SERVICE BULLETIN

SUBJECT: REPLACEMENT OF 369A8442-BASIC LATCH ASSEMBLY ON THE PARTICLE SEPARATOR BYPASS DOOR.

MODELS AFFECTED: All McDonnell Douglas Helicopter Company (MDHC) 369 Series helicopters including the 369A (OH-6A) Series helicopter.

Figure 1. Installation of 369A8442-3 Latch Assemblies

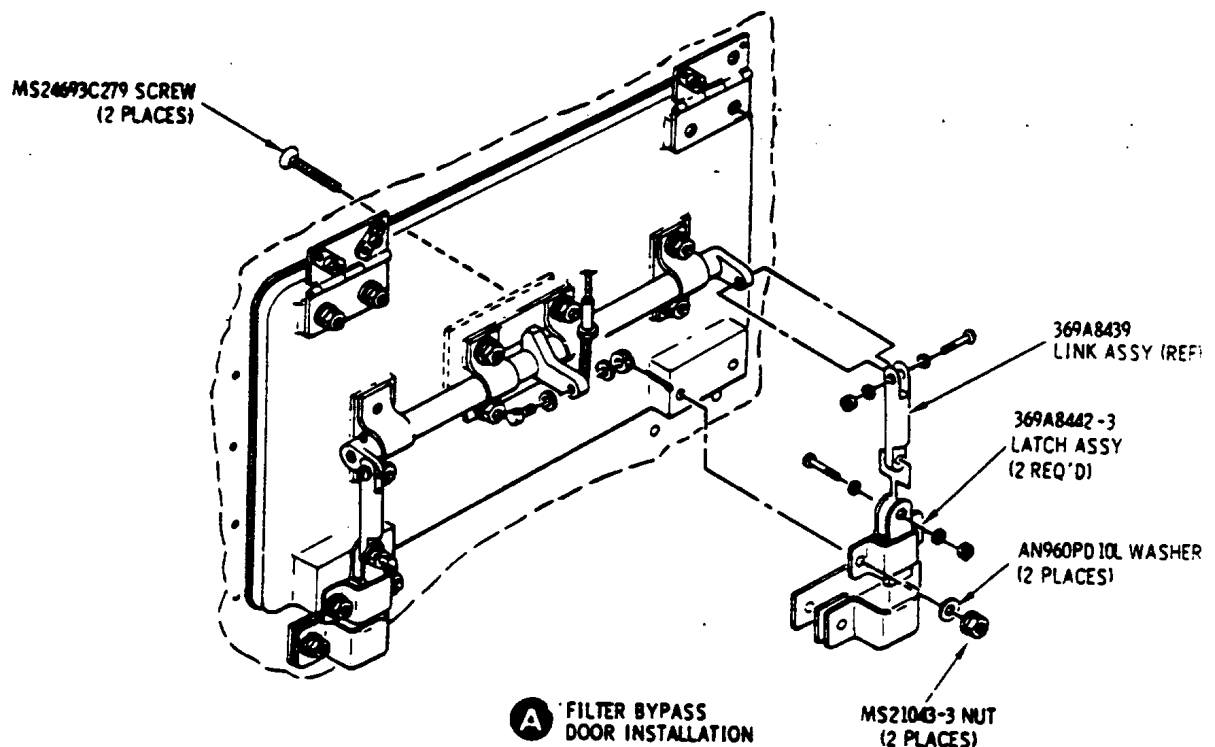
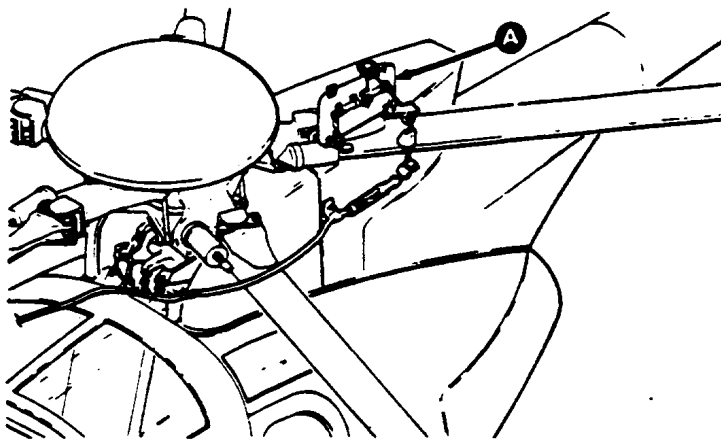
PREFACE: MDHC has received reports of the latches on the engine inlets filter bypass door fracturing and allowing the latch portion of the assembly to fall into the plenum chamber which in turn could result in damage to the engine. A new and improved latch assembly has been introduced to prevent future occurrences of this problem. MDHC is requiring operators to replace the existing latch assembly with the improved design per the instructions given in this Notice.

- a. Disconnect 369A8439 link assemblies from 369A8442-BSC latch assemblies. (See Figure 1)
- b. Remove 369A8442-BSC latch assembly. (two places)
- c. Install 369A8442-3 latch assembly in two places on bypass door.
- d. Attach 369A8439 link assemblies to 369A8442-3 latch assemblies.
- e. Remove FOD cover installed over engine air inlet. Verify that area around base of mast, inlet plenum and entire plenum chamber is free of debris and other foreign objects.
- f. Record compliance to this Notice in the compliance record section of the helicopter log book.
